Product Change Notice

PCN#: EE-PCN26003

Packaging improvement – tape and reel pocket dimensions improvement.

Tape & Reel pocket dimensions comparison, before and new reel pocket design.

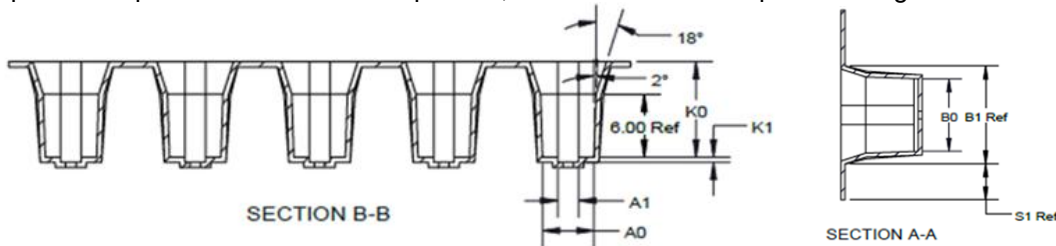
Improved tape and reel pocket dimensions design for better component fit into pocket cavity.

Pocket Dimensions (Unit: mm)	Pocket Design	A0	B0	K0	K1	B1	S1
Before		5.20±0.10	9.20±0.10	9.70±0.10	undefined	undefined	undefined
New		5.00±0.10	9.00±0.10	9.30±0.10	0.50±0.10	12.50	4.60
